2026 James Park Renovations and Pathway Improvements

Bid # 26-15

ADDENDUM No. 3

April 3, 2026

DRAWN BY:	PROJECT:
SD	26-4004
CHECKED BY:	SCALE:
SN	VP SCALE
DATE:	SHEET:
04/01/2026	3 OF 3
SHEET NO:	
S-2

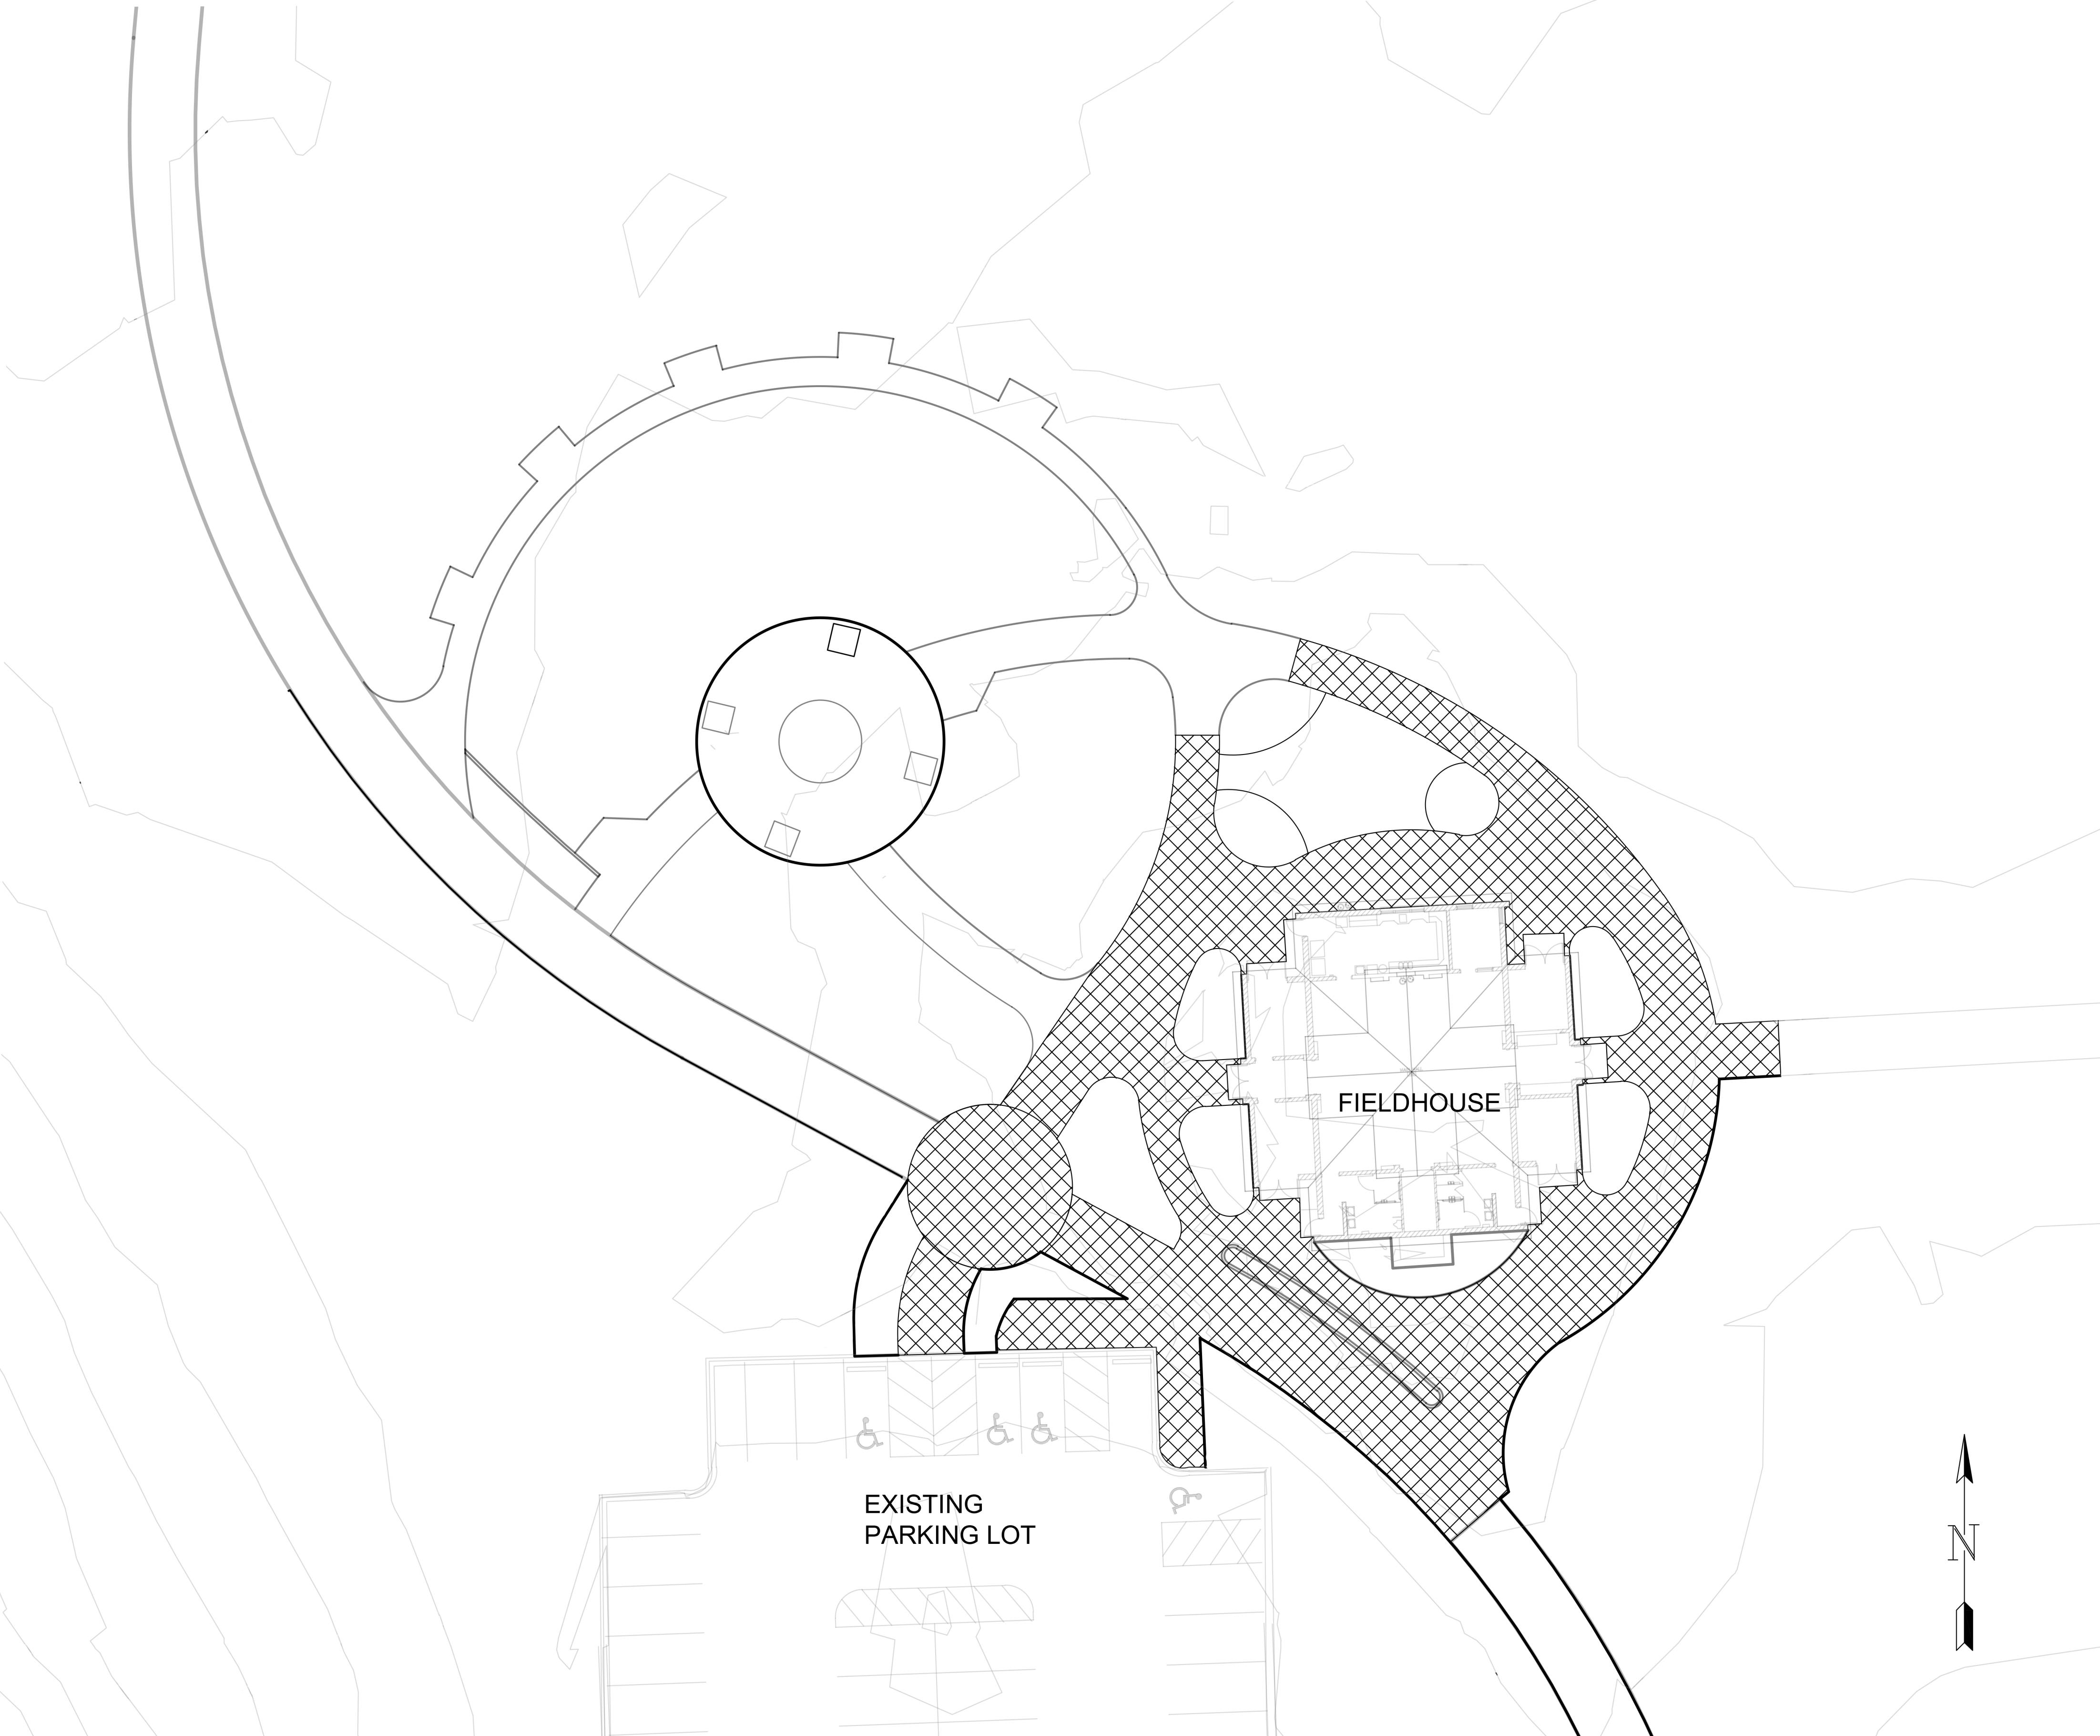
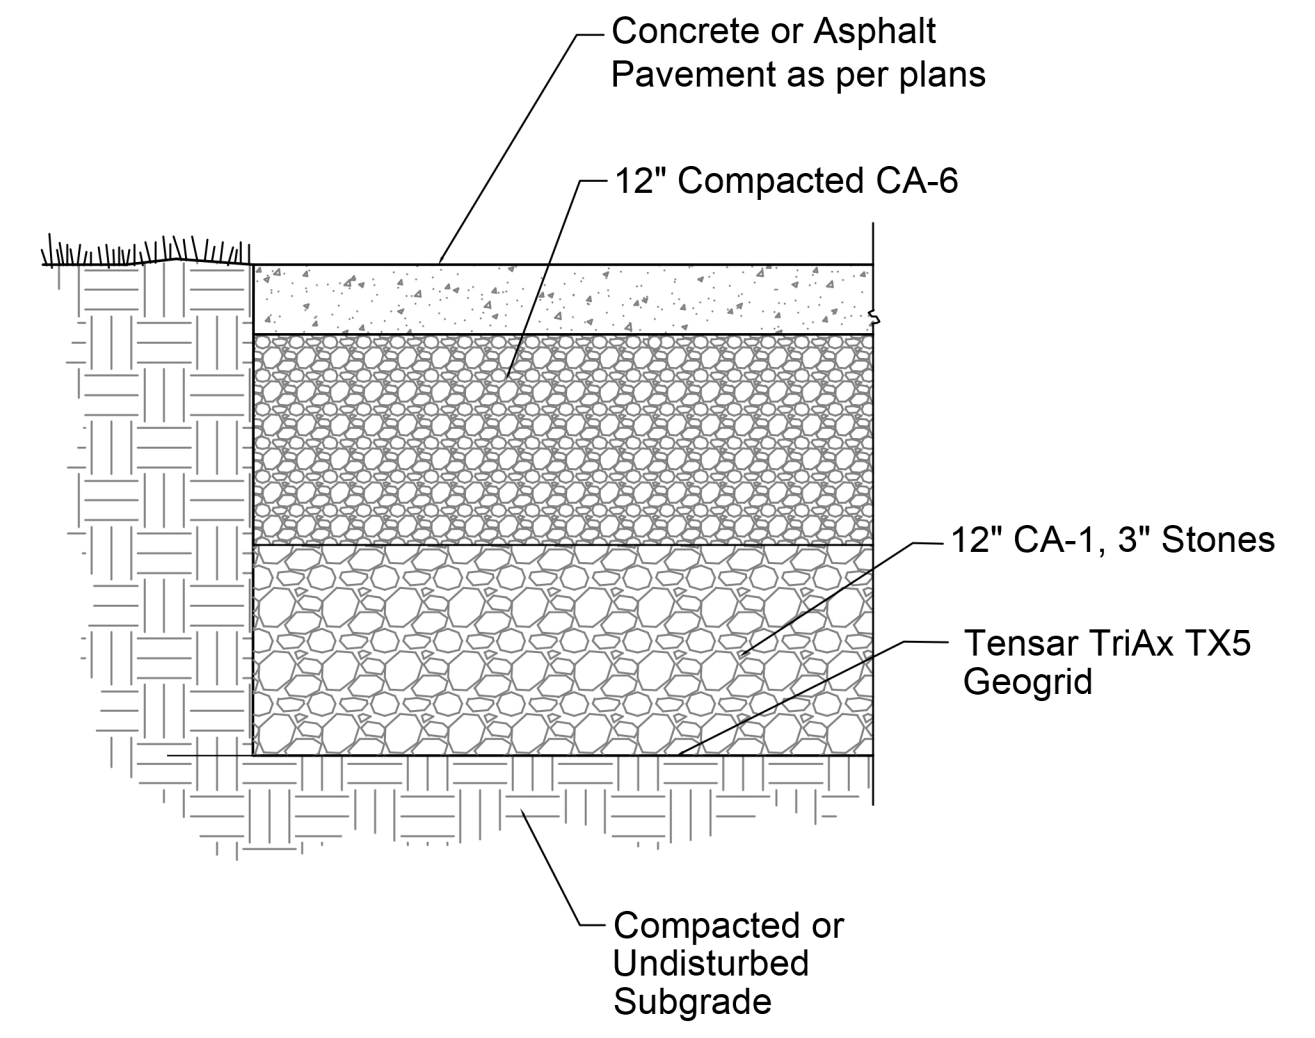
Sheet S-2 - attached

- New drawing: Defining Alternate 4 - Structural Base extents.
